MORGAN / HARBOUR
CONSTRUCTION

**Re: 703-723 W. Algonquin Rd – PUD Amendment – Amendment to PUD Ordinance 18-014 PC#20-016
– Round 2**

The following is our Planning Commission response Letter addressing the comments as outlined in the Village of Arlington Heights Building & Life Safety Department Interoffice Memorandum regarding the aforementioned project:

HAMILTON PARTNERS ARLINGTON HEIGHTS INDUSTRIAL
ARLINGTON HEIGHTS, ILLINOIS
SITE GEOMETRIC & PAVING PLAN - PHASE 2 (FRITO-LAY)

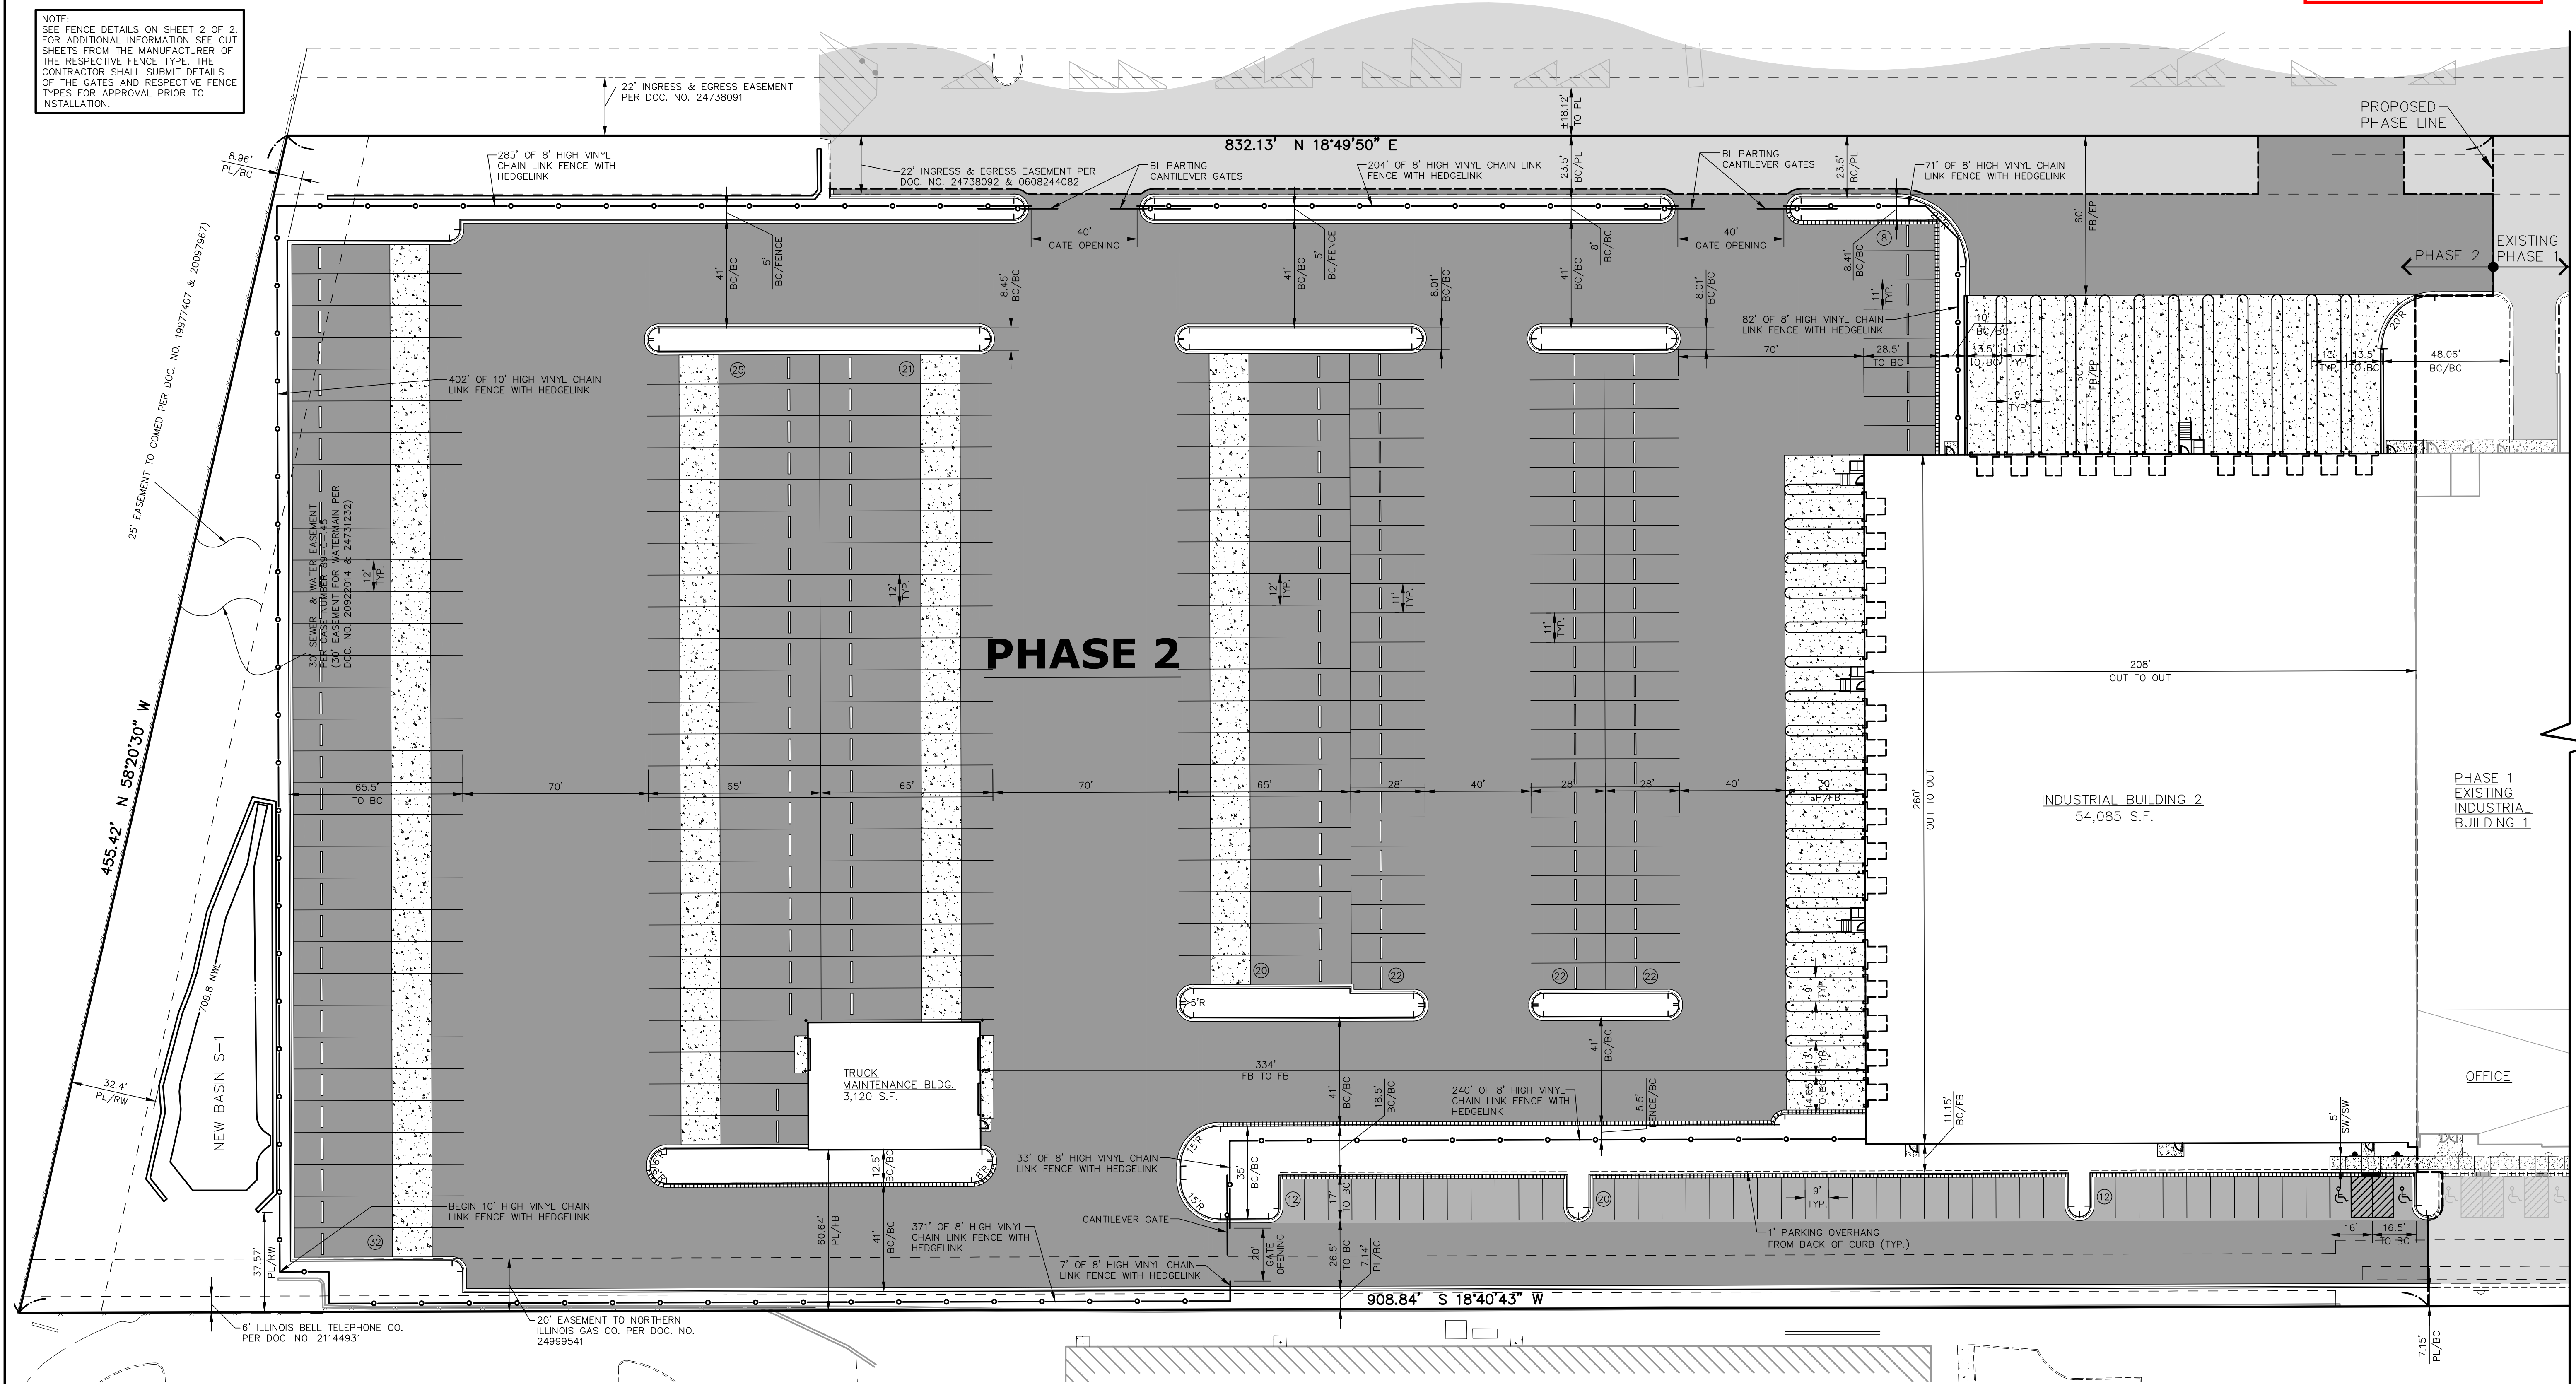
31. **Response:** Noted
32. **Response:** Noted, revised counts are included on the architectural site drawings (Exhibit F).
33. **Response:** Parking spaces confirmed and shown on revised drawings (Exhibit D and F).

25. **Response:** Noted
26. **Response:** Revised engineering sheet is included (Exhibit D). For the variation request see above response to #21 f. Included are the cutsheets for the "Hedgelink" fencing product (Exhibit B) which would be for both 8' and 10' sections as the previously proposed product is not available at 10' height.
